ADDENDUM NO. 4

04/15/2026

YWCA OF GRAND ISLAND WYANDOTTE RENOVATION

315 WYANDOTTE ST

SHEET A2.00 - DEMOLITION PLAN

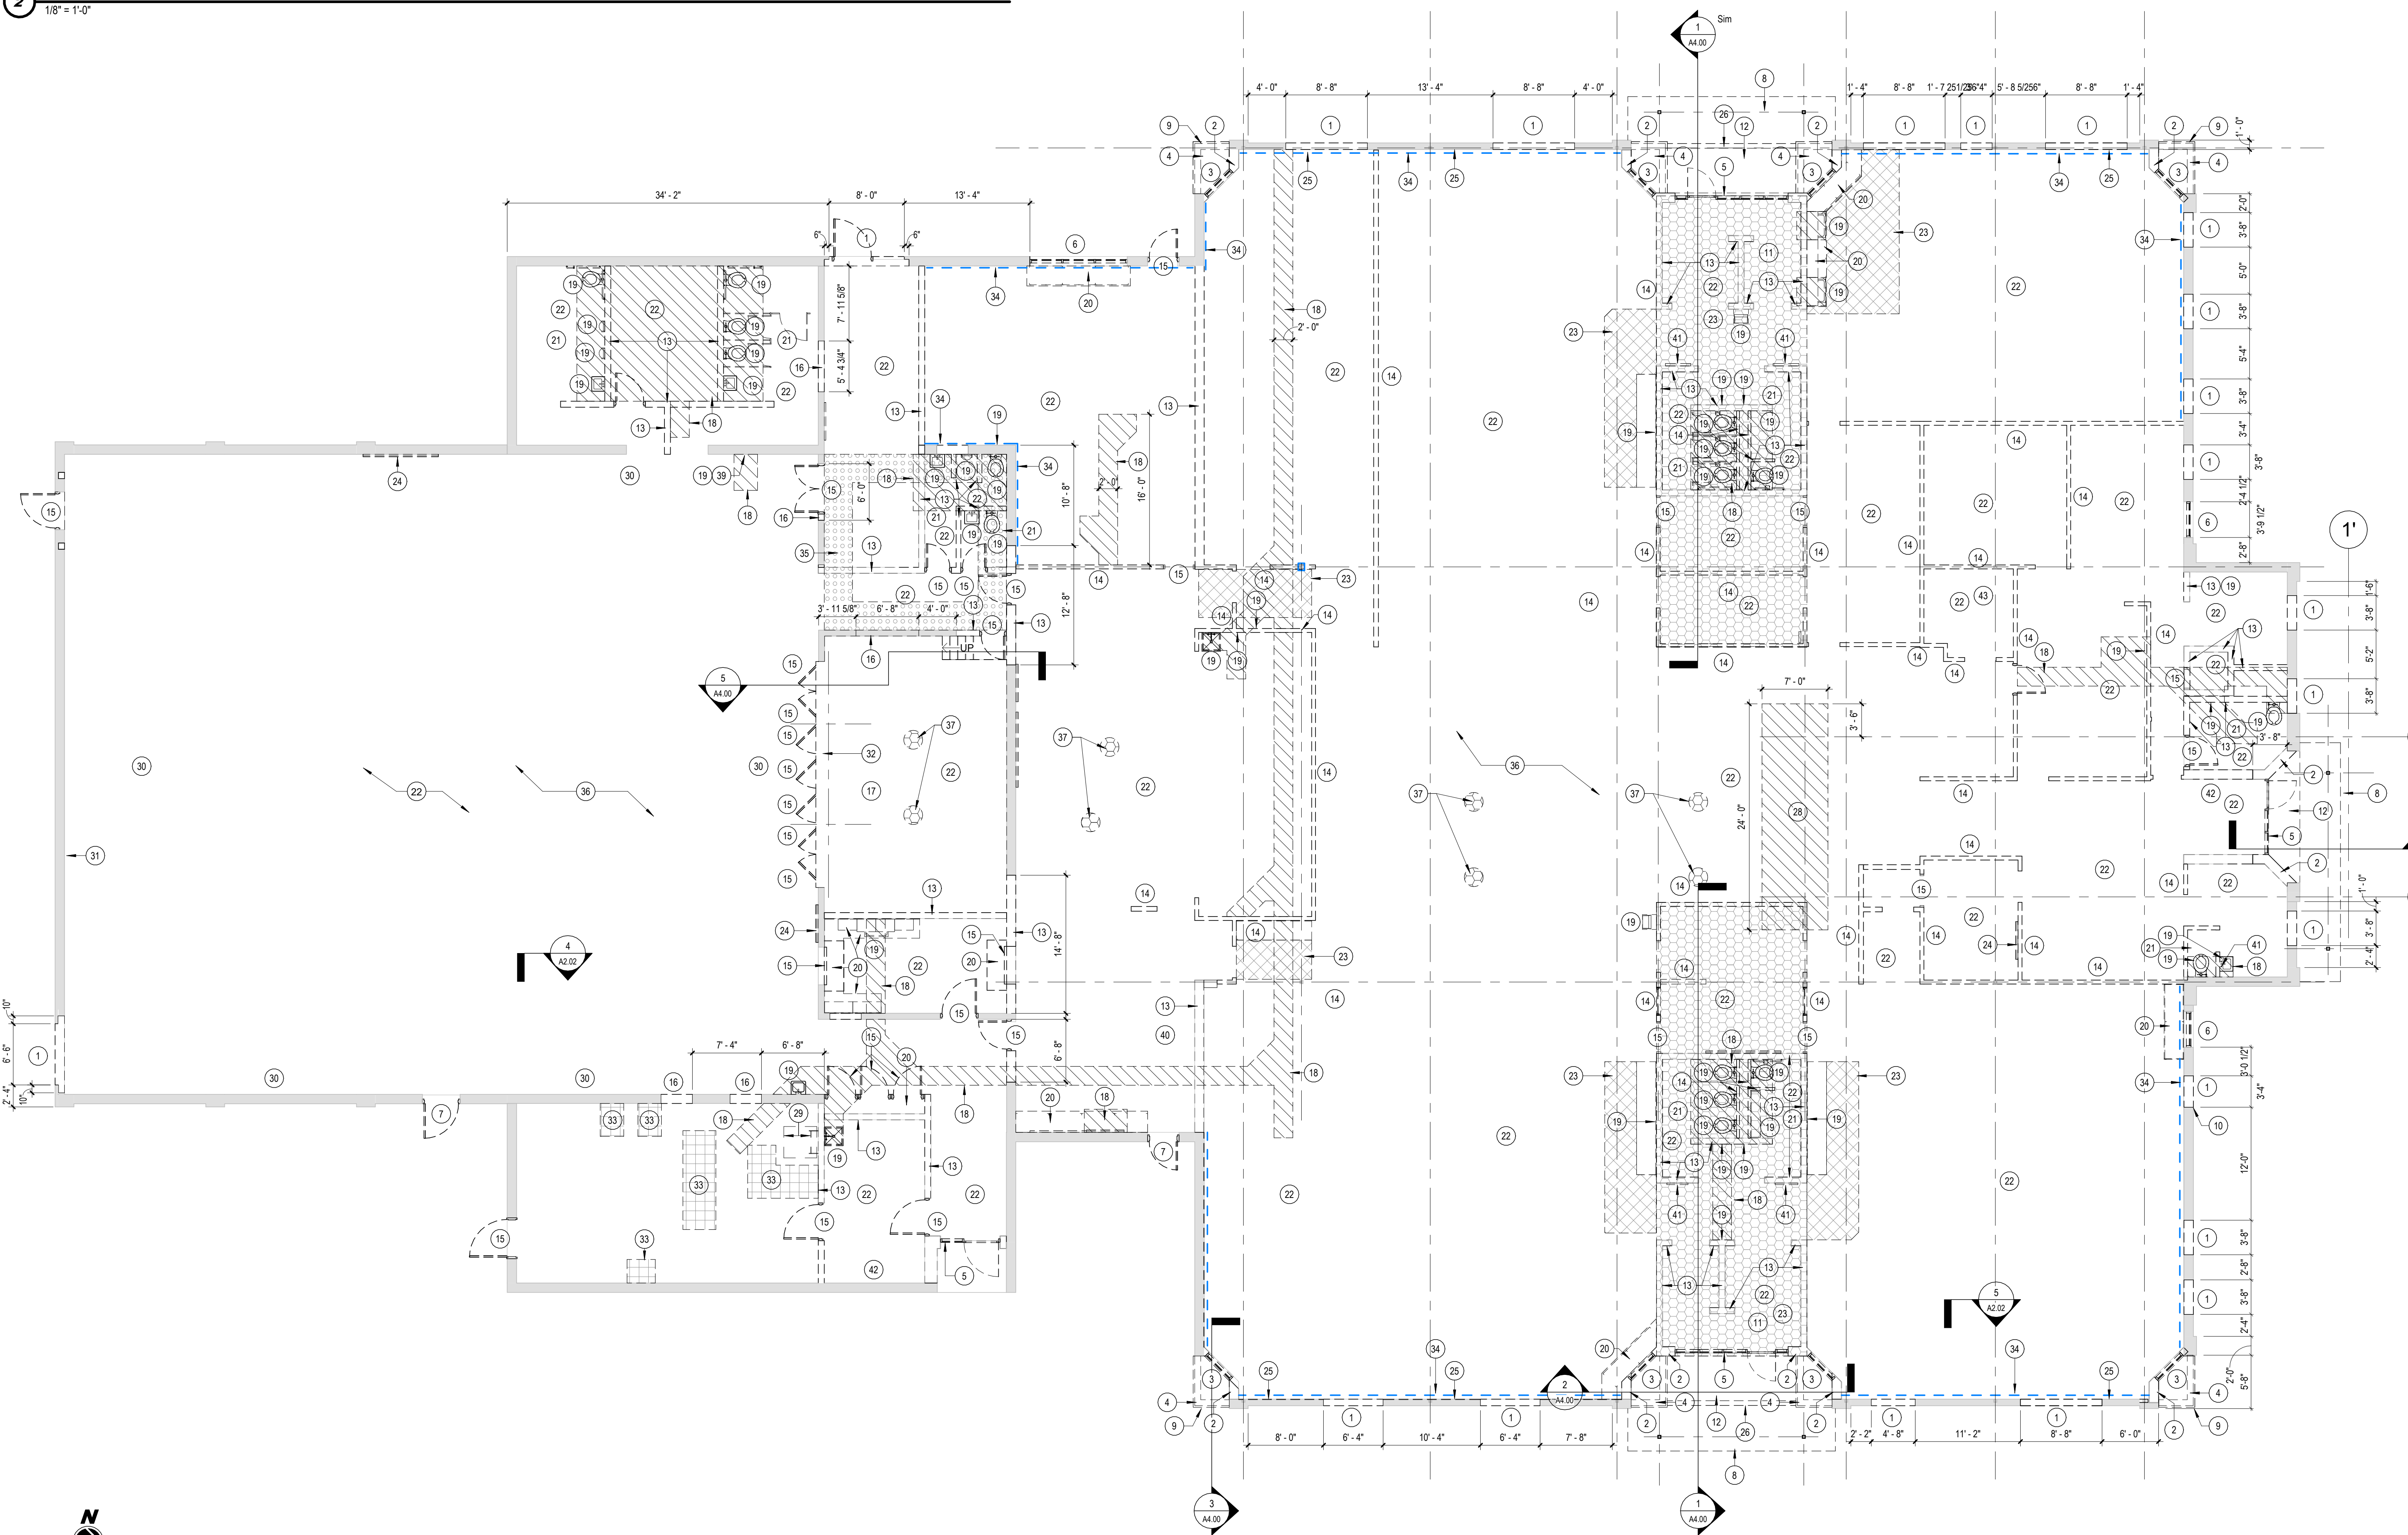
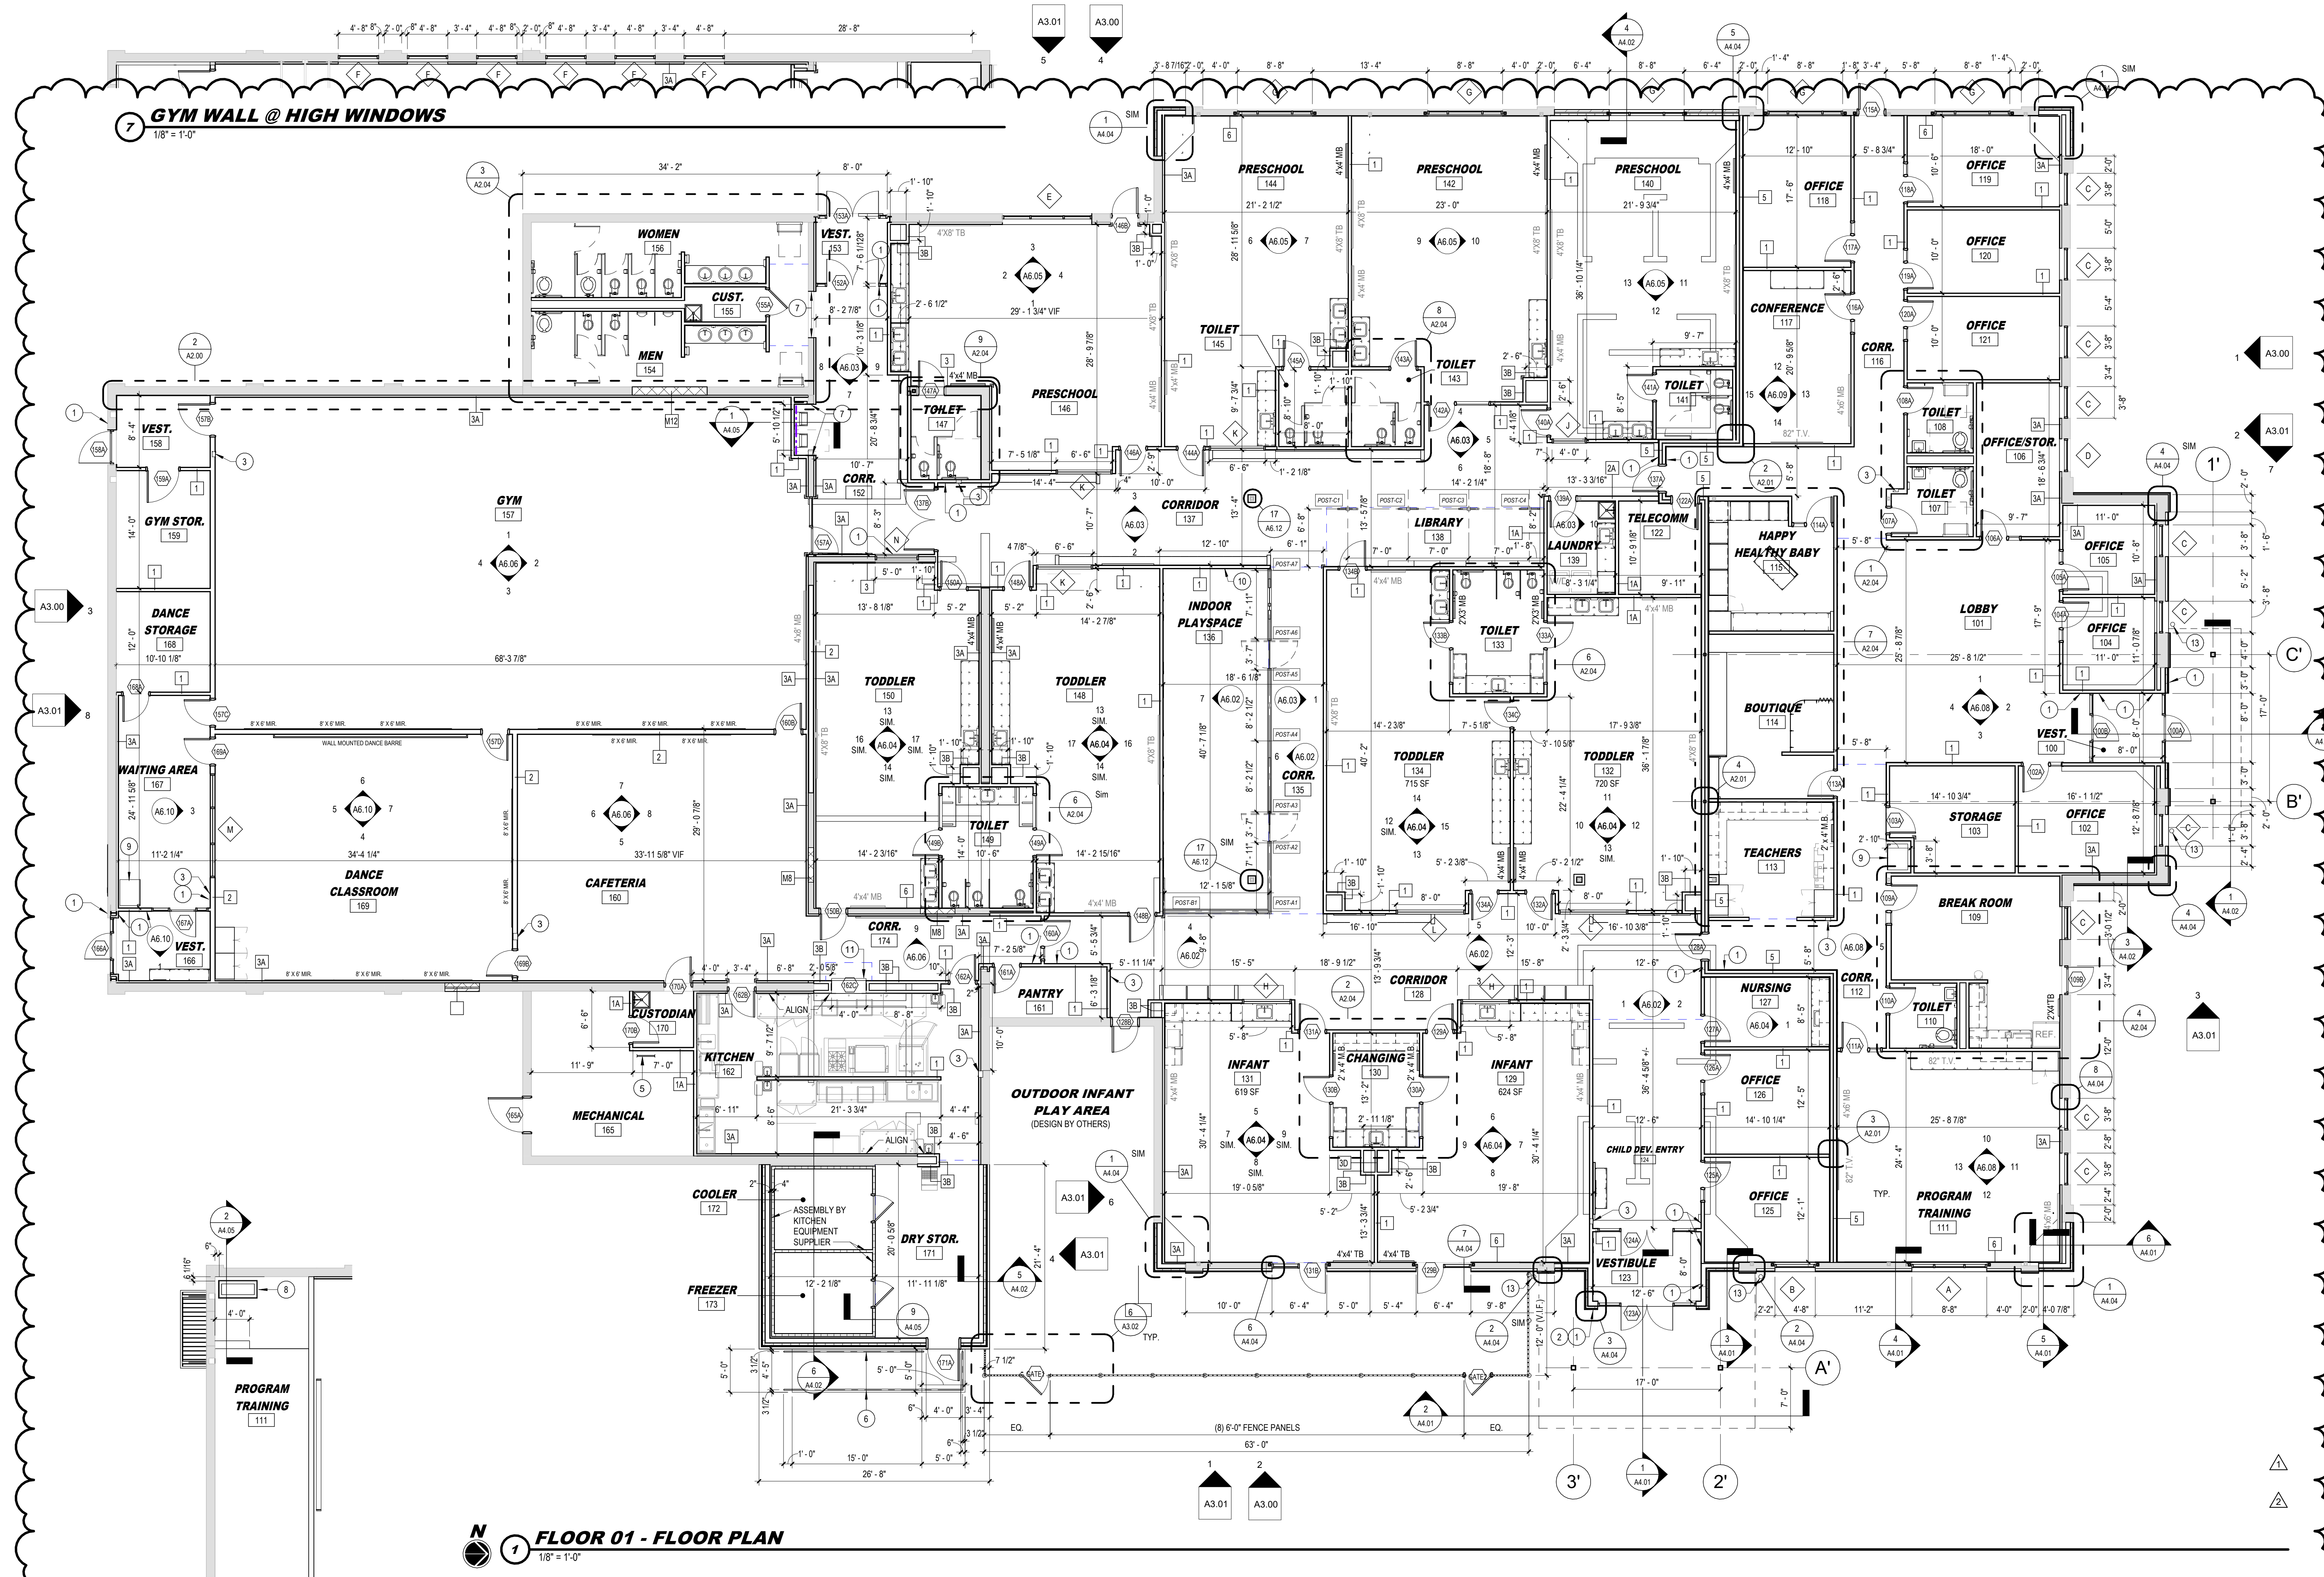
1. General Plan Revisions
 - a. Items were removed from plan
 - b. General notes and keynotes were added
